Access Compliance Report

Public Rights-of-Way

(Curb Ramps)

Intersection ID: 2743	Main Street: BELL'S_MILL_DR	Cross Street: HIGHLAND_CREEK_PY	Location: SW
ADA ID: 7AEE871647B2	Ramp Type: Perp	Initial Pass/Fail: Fail	Overall Compliance: No
			Severity Score: 33.75

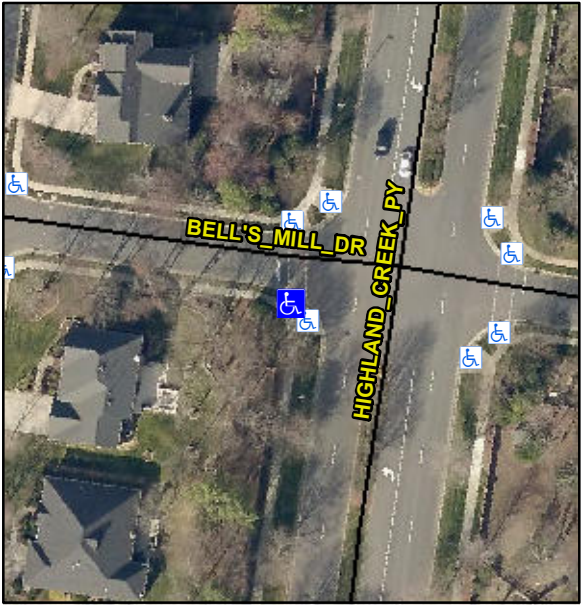
Codes/Mitigation Info/Possible Solution			Field Measurements/Component Compliance		
	Possible Solutions:		Compliance	Description	Data
	Remove & Replace Entire Ramp.		N/A	Ramp Length (in)	78.0
			No	Ramp Width (in)	40.0
			N/A	Flare Type LT	N/A
			N/A	Flare Slope LT (%)	N/A
			N/A	Flare Traversable LT?	N/A
			N/A	Landing Length (in)	N/A
			N/A	Landing Width (in)	N/A
			N/A	Landing Slope (%)	N/A
			N/A	Landing X Slope (%)	N/A
<p>Surveyor Notes:</p> <p>N/A</p> <p>PROW/ADA:</p> <p>R304.5.1, R304.2.2, R304.5.3</p>			N/A	Flare Type RT	N/A
			N/A	Flare Slope RT (%)	N/A
			N/A	Flare Traversable RT?	N/A
			N/A	DWS Provided?	N/A
			N/A	DWS Contrast?	N/A
			N/A	DWS Length (in)	N/A
			N/A	DWS Full Width?	N/A
			N/A	DWS Offset (in)	N/A
			N/A	Shared Landing?	N/A
			N/A	Gutter Ponding?	N/A
			N/A	Gutter Lip Ht (in)	N/A
			N/A	Painted X Walk1?	Yes
				X Walk 1 Direction	To N
			N/A	X Walk 1 Width (in)	95.0
				X Walk 1 Slope (%)	3.4

X Walk 1 X Slope (%)	6.9
			N/A	Ramp inside XWalk1?	Yes
				Road Slope (%)	N/A
				Road X Slope (%)	N/A
			N/A	Any Obstructions?	N/A
				Obstruction Type	
Total Cost:		\$ 1850.00			
			N/A		
			Yes	Surface Condition? (G/P)	Good
